General comments

The paper investigates interferences caused by volatile organic compounds (VOCs) in the photoacoustic measurement of ammonia in air on agricultural farms. The commercially available PAS instrument that was used in this work contains a broadband infrared light source and six optical filters for spectral selection. The filter set is suitable for the specific detection of NH₃, CH₄, CO₂, H₂O, N₂O and SF₆ in atmospheric mixtures at ppmv level, if no other absorbing species interfere. The experiments described in the manuscript show very clearly that VOCs, such as methanol, ethanol or acetic acid observed in a dairy farm can cause significant interferences and are detected by the PAS instrument with higher sensitivity than ammonia. Similar results are found for greenhouse gases that are measured by the PAS instrument. A comparison to a reference technique (PTR-MS), which measured ammonia and VOCs, demonstrates that the PAS instrument can overestimate ammonia concentrations by up to an order of magnitude due to spectral interferences by VOCs. The authors conclude that the PAS measurements of ammonia can be corrected, if the concentrations of the interfering VOCs are know

Fig. 1 Centre wavelength and half-power bandwidths of the optical filters

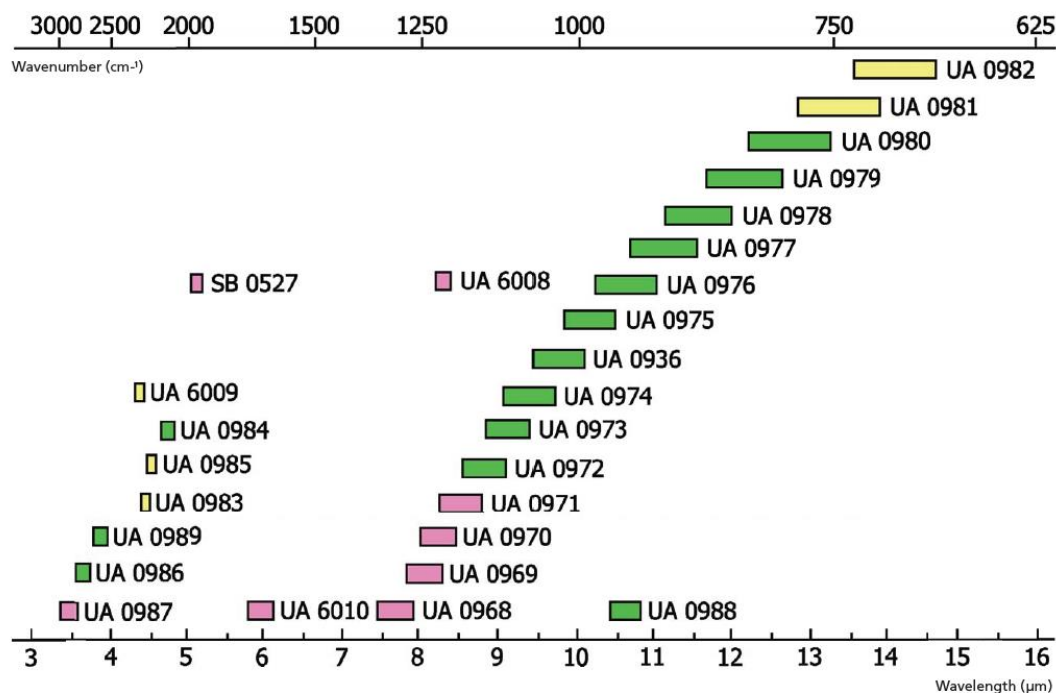
5. Line 62 ff. Here and in Section 2.1, more details of the measurement principle of PAS should be given. What kind of light source is used (spectral range, emission bandwidth, continuous or pulsed)? What causes the cell pressure changes? How are they detected? What is the range of optical absorbances? Is the signal linearly dependent on the concentration of each analyte? Does the method need regular calibration by the user and how is calibration achieved?

32. Table S1. "Filter center" should be changed to "Center wavelength". What is the meaning of "Band width (%)" ? Is it related to "Filter bandpass"?

Response: The infra-red light source is used. Innova 1312 used the filter of UA0982 (CO₂), UA0985 (N₂O), UA0936 (NH₃), UA0972 (Freon 134a), and UA0969 (CH₄). Infrared radiation can interact with a molecule and transfer energy to it if the frequency of the radiation is exactly the same as the frequency of a vibration within the molecule. When the molecule absorbs this radiation it vibrates with greater amplitude. This increased activity is short-lived, however, and the excited molecule very quickly transfers its extra energy to other molecules in the vicinity by colliding with them and causing them to travel more quickly. The increased molecular speeds means that the temperature in the measurement chamber increases and when the chamber is sealed the pressure also increases. The amount of light absorbed can be measured by measuring either the heat energy released or associated pressure increase. Both parameters are proportional to the concentration of the absorbing species. Because calorimetric detectors have slow response times and are insufficiently sensitive, the pressure increase is the preferred

measurement parameter. A microphone is an excellent detector of fluctuating pressure. It is stated on the brochure of Innova 1312 'Linear response over a wide dynamic range'. On the manual of Innova 1312, there is a chapter to explain how the users can conduct a self-calibration after moving the instrument around. In our experiments, the instrument was calibrated by the

company and the instrument was calibrated on a certified gas cylinder of NH₃ in the lab. Now more details are given in the revised manuscript, section 2.1 (please see Line 171-186).

Response: "Filter center" is now changed to "Center wavelength" as suggested. Yes the "Band width (%)" is related to "Filter bandpass" which is calculated based on the center wavelength and band width (e.g., $2171 = 2215 - 2215 * 2.0 / 100$ for UA0985).
